ASSESSMENT REPORT

Section 75W Modification

Sandvik Machine Manufacturing and Maintenance Project

Figure 5: Originally proposed temporary access point

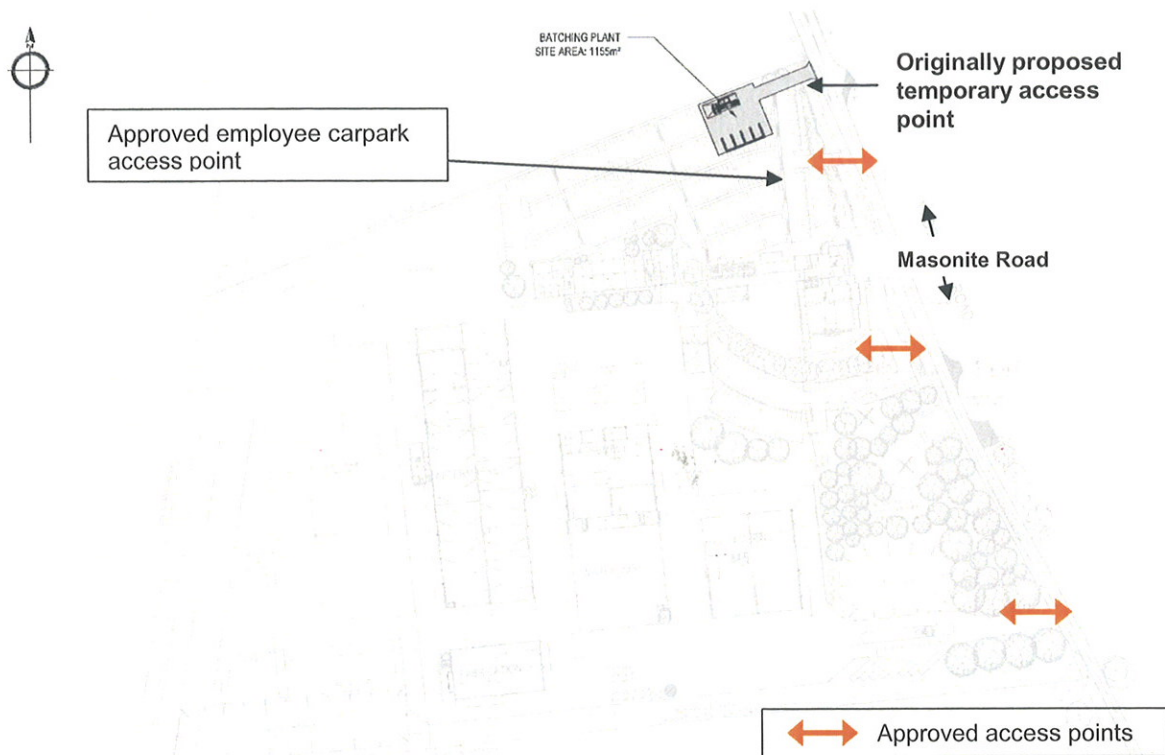
The Department sought advice from Council regarding the proposed location of the additional temporary access point off Masonite Road and asked Council to provide the Department with confirmation that the proposed access point was safe given existing traffic conditions.

Council subsequently advised that the proposed temporary access point would interfere with the access of another industrial premise and a deceleration lane located directly opposite the site on Masonite Road. Council recommended that the temporary access be relocated further to the south, to the access point for the employee carpark of the approved project (see Figure 5 above).

Sandvik has amended the location of the proposed temporary access point, consistent with the above (see Figures 6). Council and the Department are now satisfied that the proposed access is safely and suitably located for integration with existing traffic conditions.
